NINE MILE POINT NUCLEAR STATION UNIT NO. 1  
INDIVIDUAL PLANT EXAMINATION  
TECHNICAL EVALUATION REPORT

NINE MILE POINT UNIT 1  
TECHNICAL EVALUATION REPORT ON THE  
INDIVIDUAL PLANT EXAMINATION  
BACK-END ANALYSIS

Prepared for the U.S. Nuclear Regulatory Commission  
Under Contract NRC-05-91-068-31  
August 1995

Figure 4.1-10  
Suppression Chamber General Arrangement [Ref. 159]

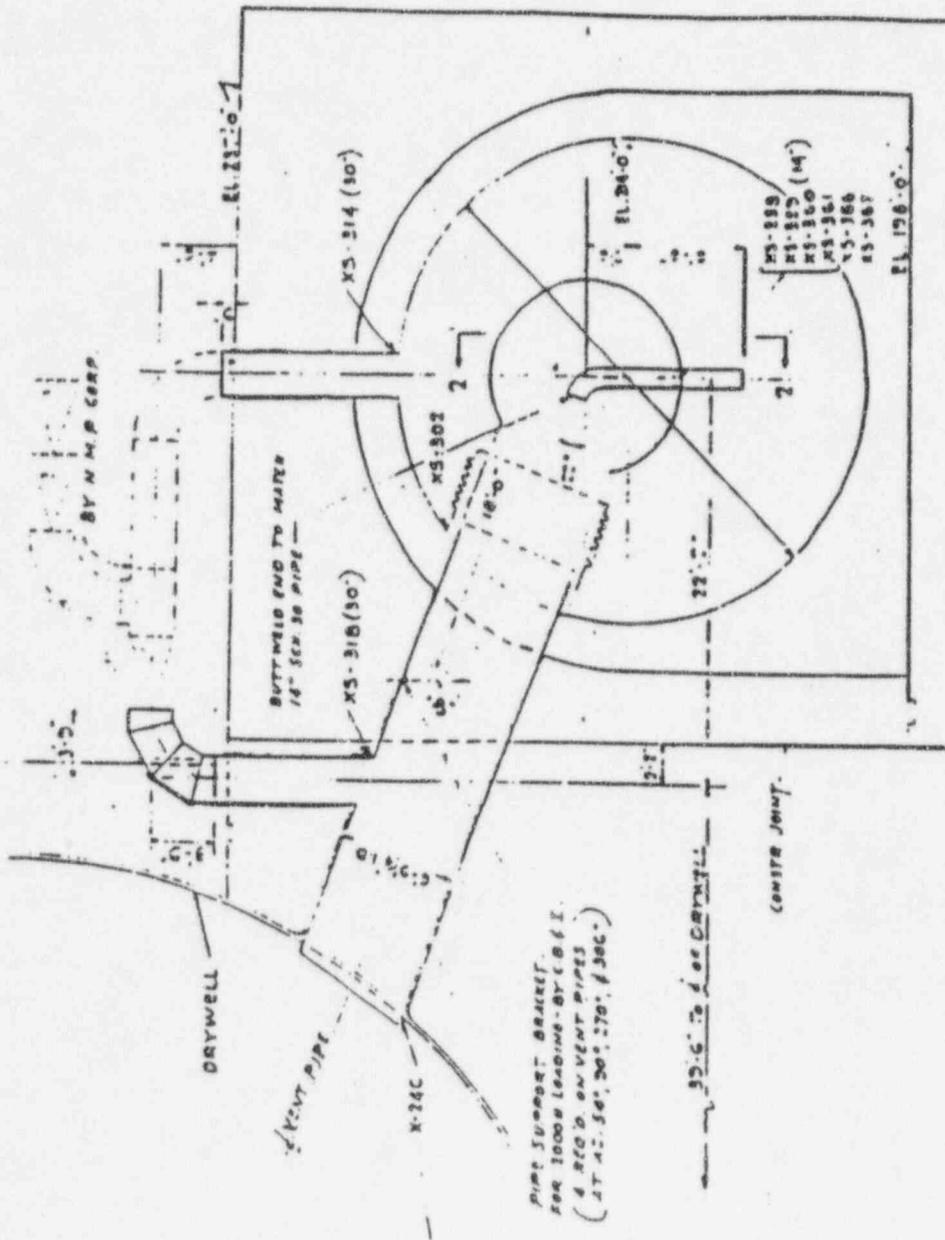
- At low temperature (approximately 200° F), the dominant failure mode would be a large failure in the wetwell airspace corresponding with the vent line bellows failure at a mean pressure of 65 psig. This is considerably lower than the failure pressure for other Mark I BWRs (e.g., 146 median psig for Brunswick and 105 mean psig for Quad Cities).

According to the submittal, this low failure pressure would be due to the fact that the single-ply vent line bellows at NMP1 is internal to the torus, which is subject to external pressure and temperature loading, in contrast to those for other BWRs, which are either subject to internal pressure or are of a two-ply design. Figure 4.1-10 of the IPE submittal, reproduced here as Figure 1, shows the bellows arrangement. The next most significant failure mode was assessed to be the rupture of the suppression chamber shell at a median pressure of 119 psig.

Figure 4.7-4  
Comparison of the Definition of 'Early' Radionuclide Release

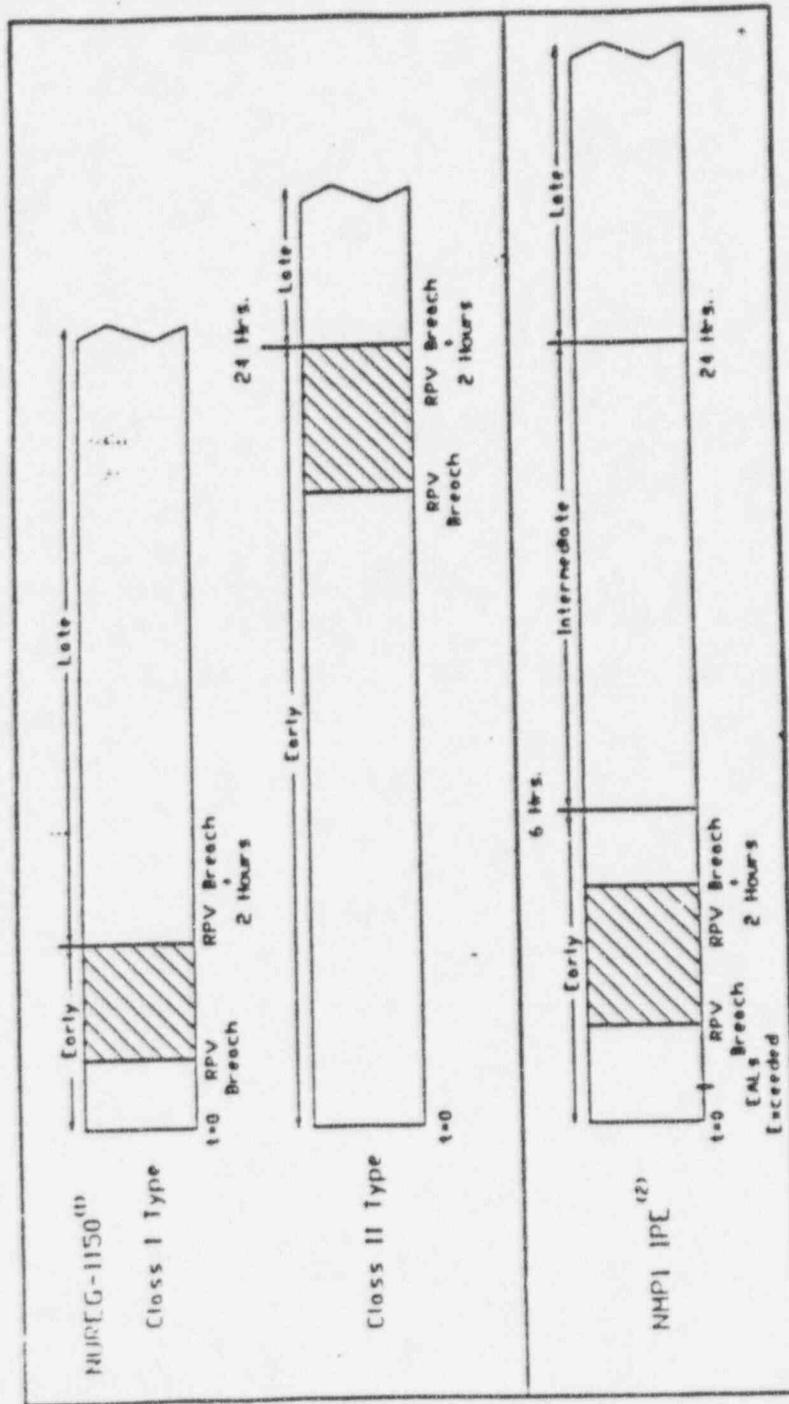
Usually, the release time is defined based on the occurrence of vessel breach. For example, NUREG-1150 defined early containment failures for BWRs as those occurring before or within 2 hours of vessel breach. Figure 2, reproduced from the submittal, compares the definition of "early" radionuclide release used in the IPE with its definition in the NUREG-1150 study. Any comparisons of NMP1 results with those of other IPEs and NUREG-1150 have to be made accordingly.

Figure 4.6-17  
Summary of Initial Containment Failure Modes:  
Contributors to Total Release

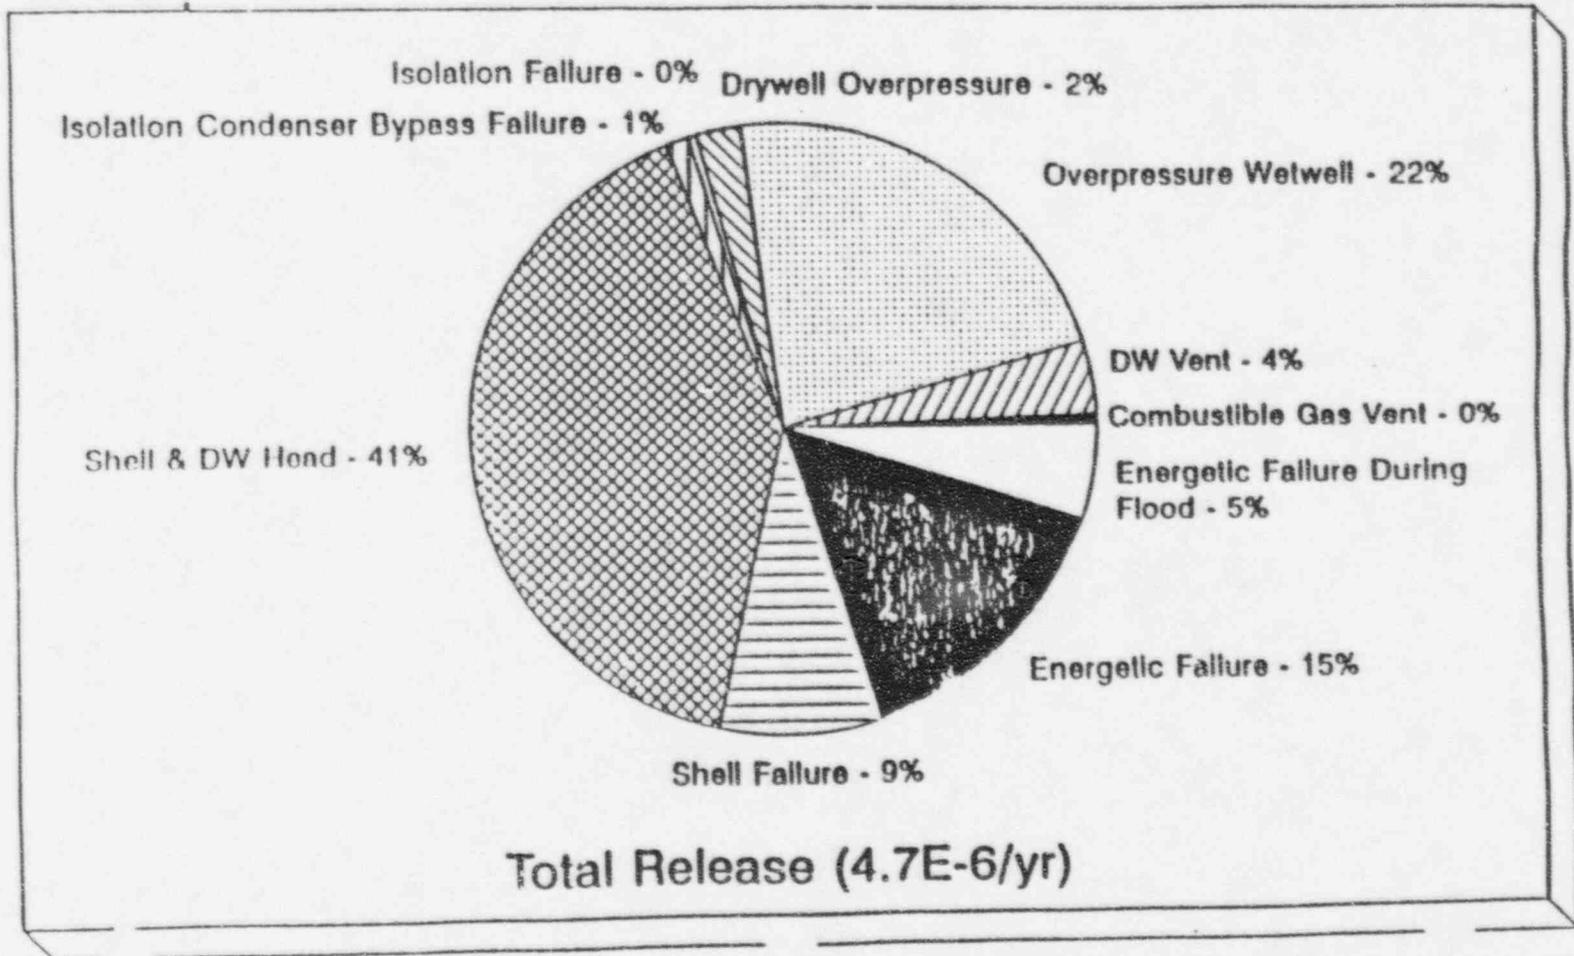
Figure 4.6-17 of the submittal shows that the principal mode of containment failure would be shell failure, coupled with a subsequent drywell head failure (41 percent of total release), followed by wetwell overpressure failure (22 percent). Energetic failure modes due to rapid overpressurization at RPV failure, steam explosion, direct containment heating (DCH), and hydrogen detonation would contribute 15 percent to the total release. Containment isolation failure probability would be negligible: the containment isolation system was shown to be highly reliable and containment normally inerted. Controlled venting of the drywell would account for 4 percent of the total release.

Figures 3 and 4, both reproduced from the submittal, show containment failure modes as contributors to total release and to "large" (early/high) release, respectively.
